IMPORTANT SAFETY RECALL

Airstream Travel Trailer
NHTSA 22V-348/Transport Canada 2022-355

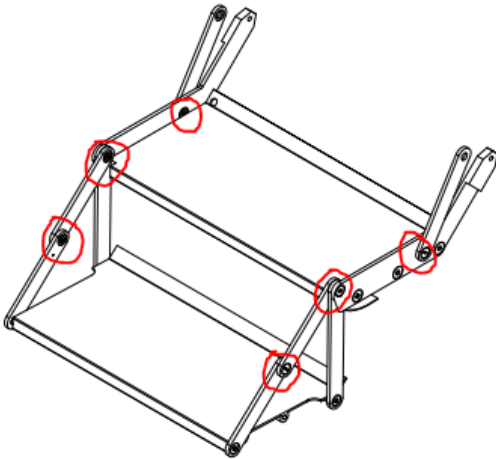
It has come to Airstream's attention that travel trailers manufactured with the aluminum step (part #: 3440006) may have a defective washer installed in the (6) washer and screw fastener locations. This step failure may be due to the washer chamfer being machined too deep, allowing the screw to be pulled through when a load is applied. This step is installed on Classic, Pottery Barn, Globetrotter, International, and Flying Cloud models.

1. Remove the screw from the step extrusion assembly using 1/8" Allen wrench and 5/32" Allen wrench or a flat head screw driver.
2. Remove the washer and replace with new washer in all six locations (supplied by Airstream Service Center).
3. Place Loctite (RED) thread locker on the threads of the screw.
4. Start screw with hands until thread engages properly.
5. Use the same 1/8" Allen wrench and 5/32" Allen wrench or flat head screw driver to tighten screw back into washer and step assembly.
